# SAN FRANCISCO PLANNING DEPARTMENT

## Discretionary Review Abbreviated Analysis

*Date:* April 26, 2019  
*Case No.:* **2017-013328DRP-04**  
*Project Addresses:* **2758 Filbert Street**  
*Permit Applications:* 2017.1013.1247  
*Zoning:* RH-2[Residential House, Two-Family]  
40-X Height and Bulk District  
*Area Plan:* N/A  
*Block/Lot:* 0952/013,  
*Project Sponsor:* Kaileen Yen  
Winder Gibson Architects  
1898 Mission,  
San Francisco, CA 94103  
*Staff Contact:* David Winslow – (415) 575-9159  
[David.Winslow@sfgov.org](mailto:David.Winslow@sfgov.org)  
*Recommendation:* **Take DR and approve with proposed modifications**

view from second floor family area

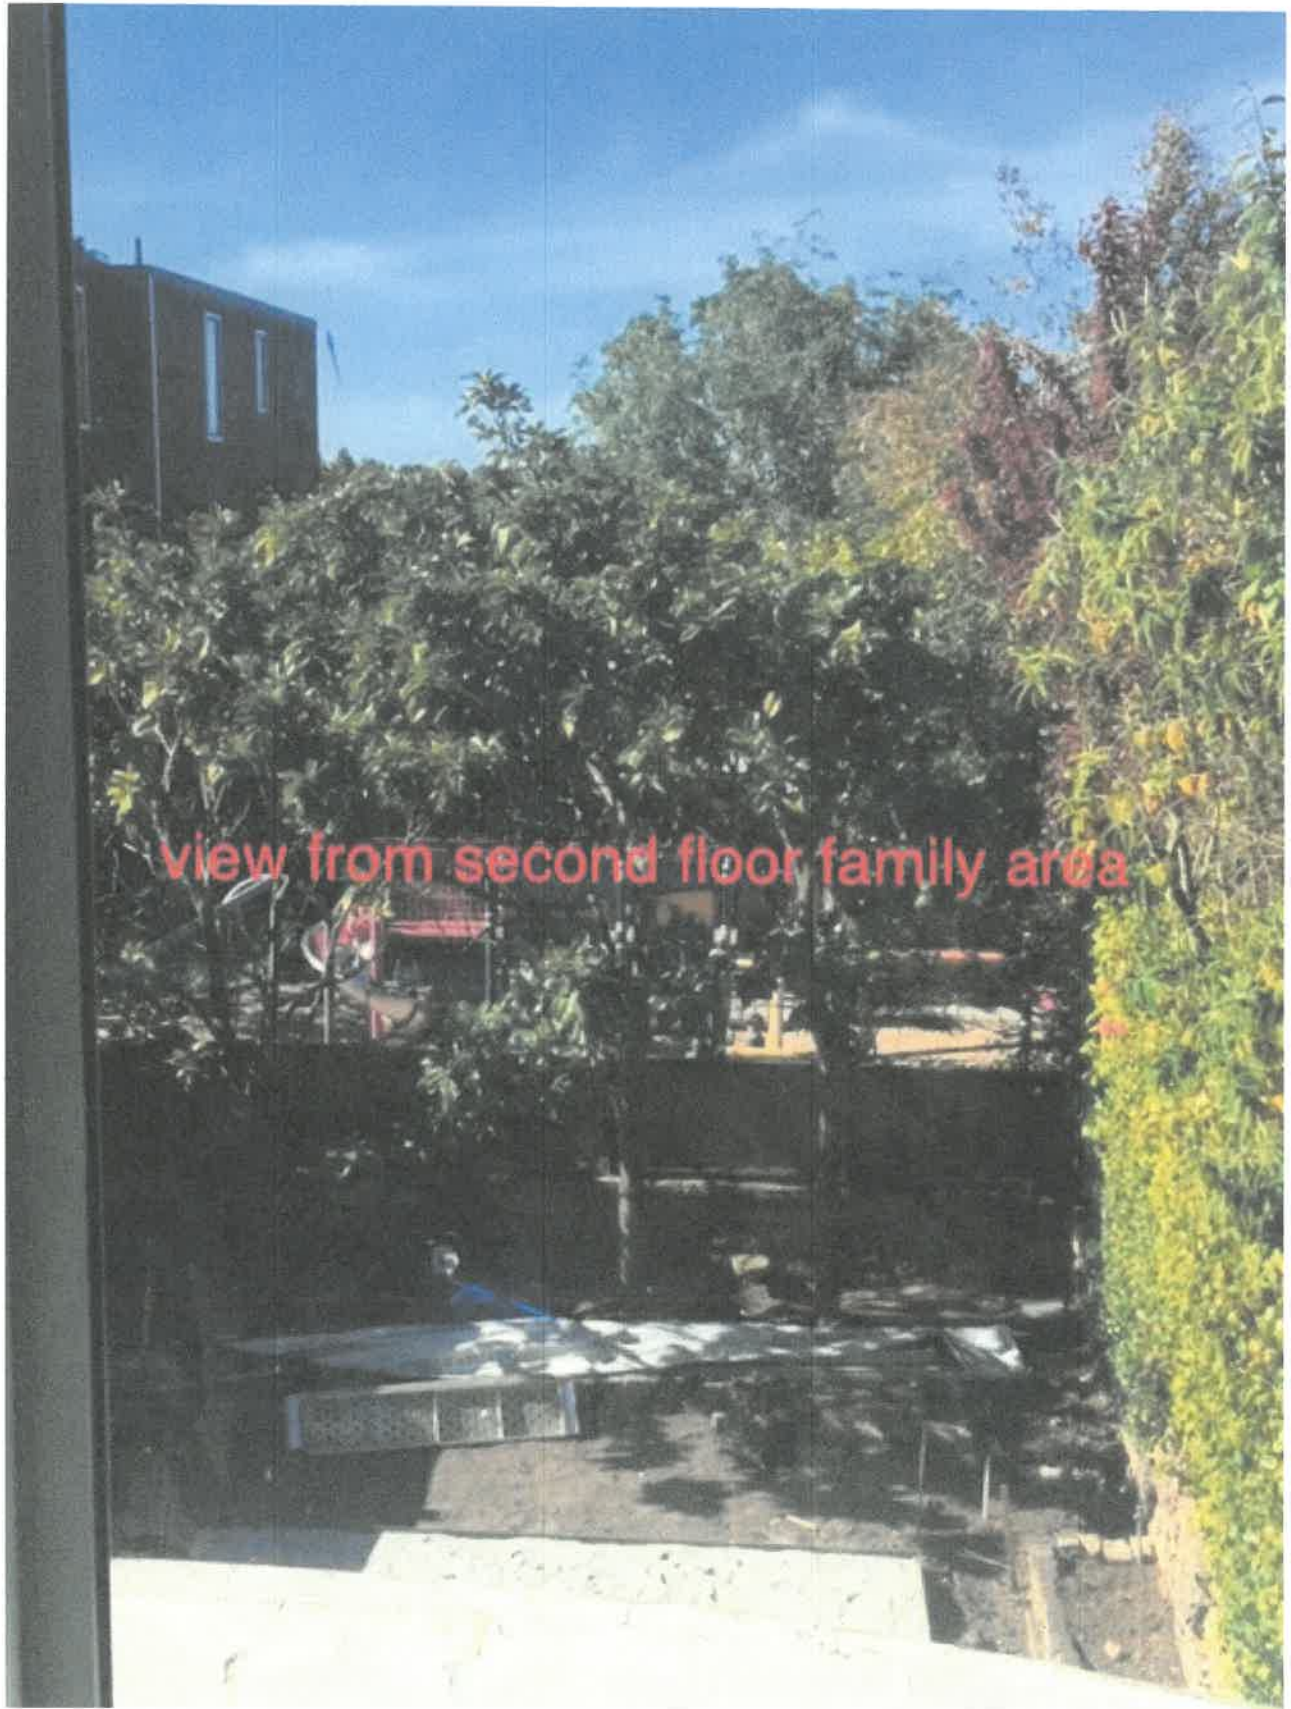
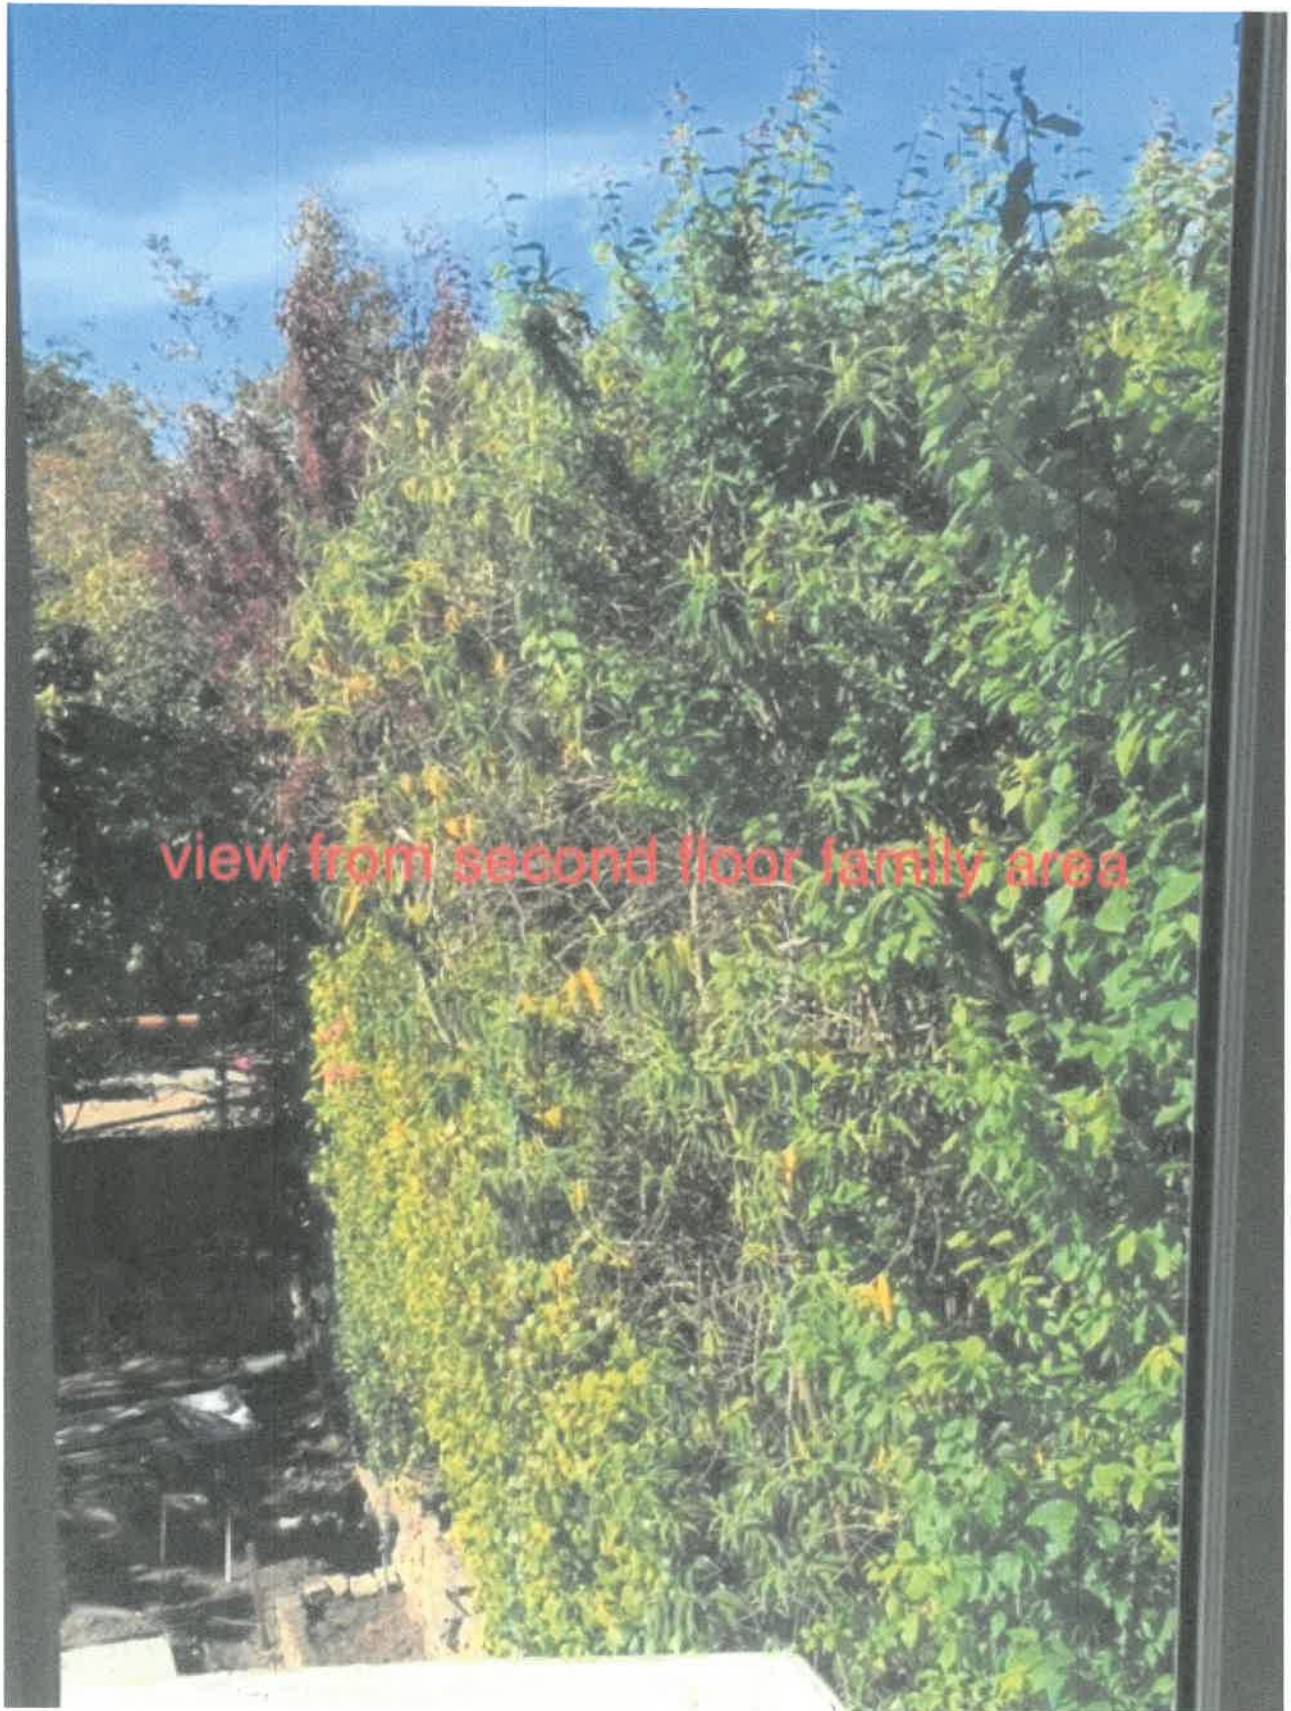
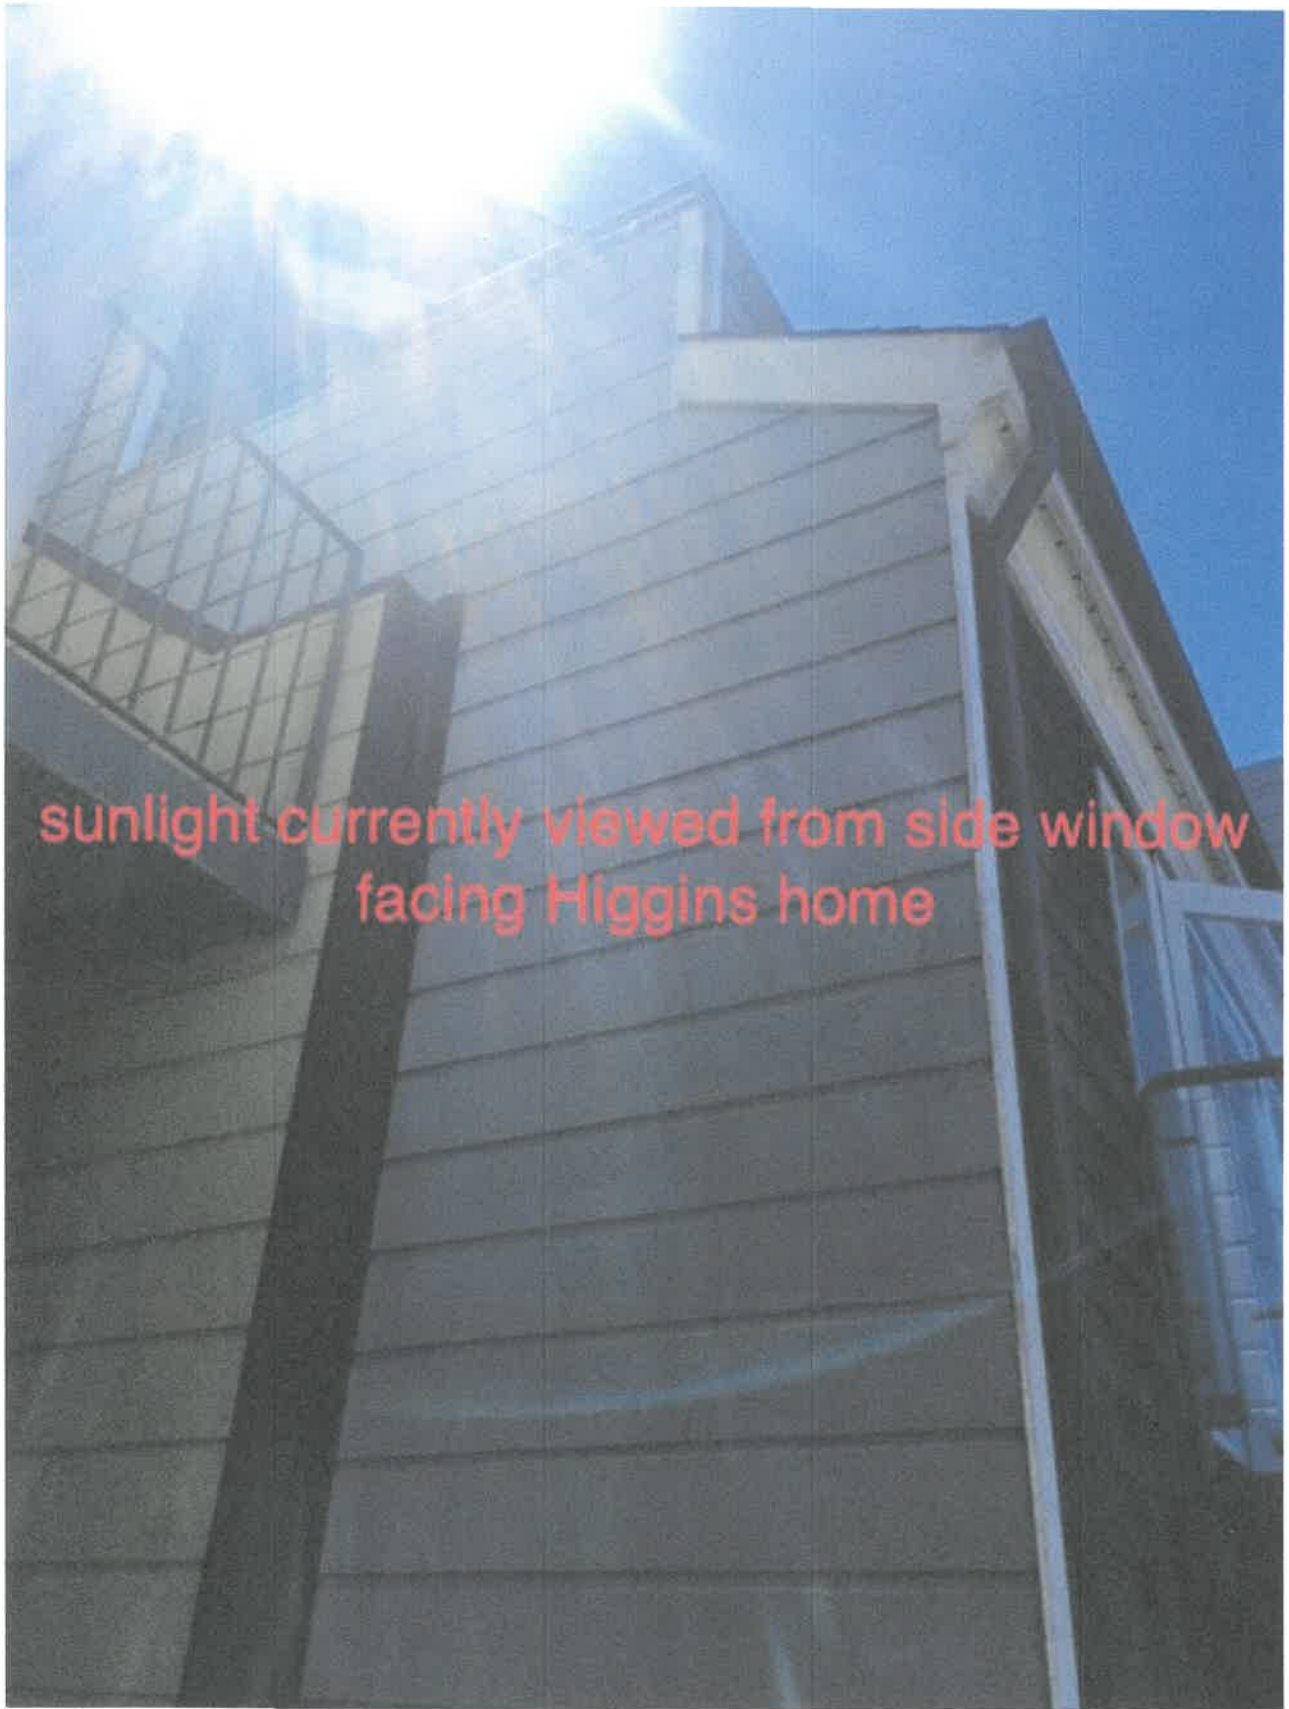
- Our third floor office will be heavily shadowed by the deep push out of the proposed Higgins home. The dismissive recommendation from Mr. Higgins is for us to build a larger window.

direct sunlight from side window in family area

sunlight currently viewed from side window  
facing Higgins home

Photo 2: Example of Rear Wall Averaging on Filbert Street.

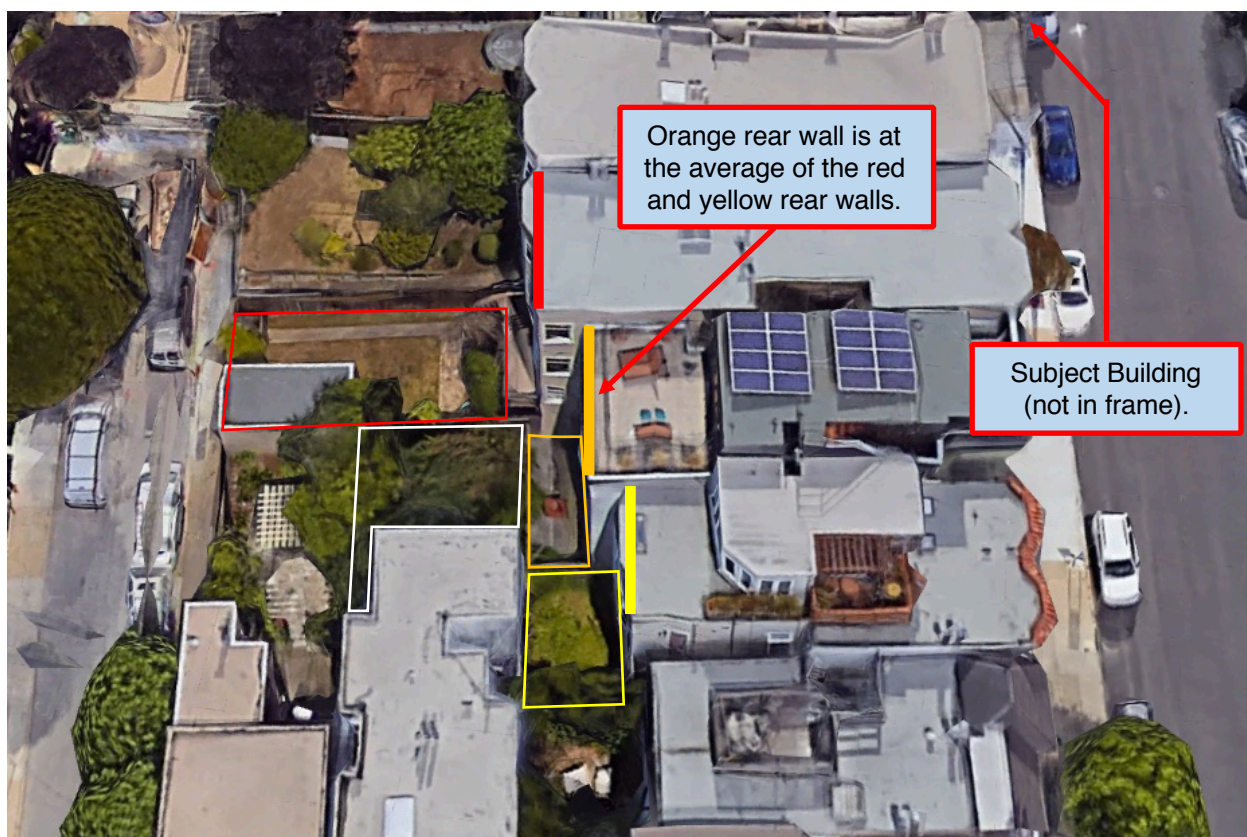
An existing and close-by example of the same circumstance (i.e., different lot sizes and rear yards) is shown in the photo below, also from the 2700 block of Filbert Street. The rear wall of the middle building (in orange) averages the rear walls of: (a) the top building (in red); and (b) the bottom building (in yellow), despite three vastly different rear yards and lot sizes.

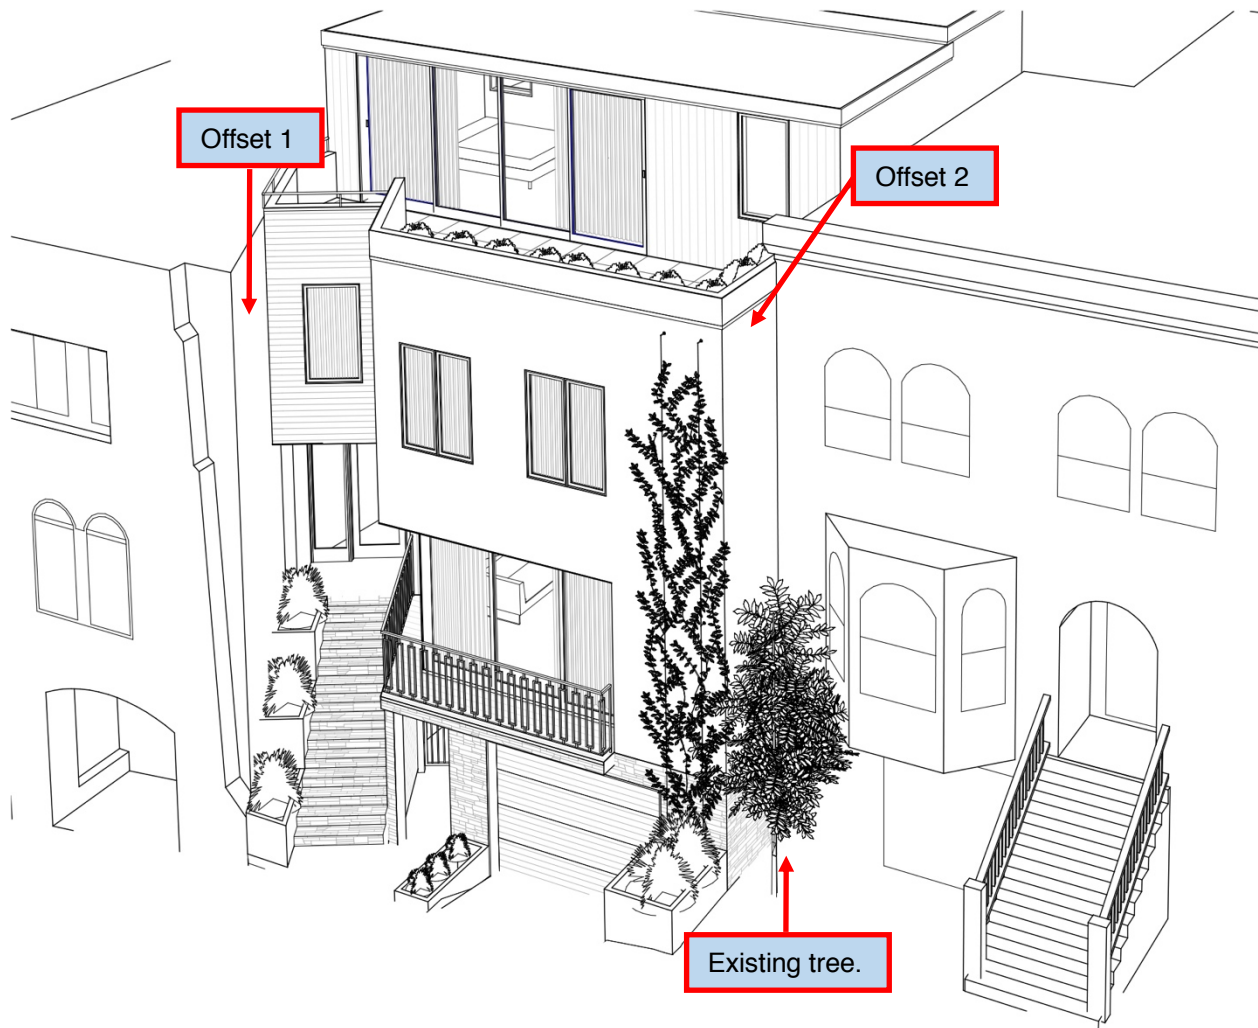
- 8.2. The sponsors have employed the first method—an entryway stair—to soften Offset 1 in the rendering below.
- 8.3. The Dallmars can employ landscaping (the third method) to soften Offset 2—as they already have, in fact, done with an existing tree. Their own bay window also helps soften Offset 2 (via the second method).
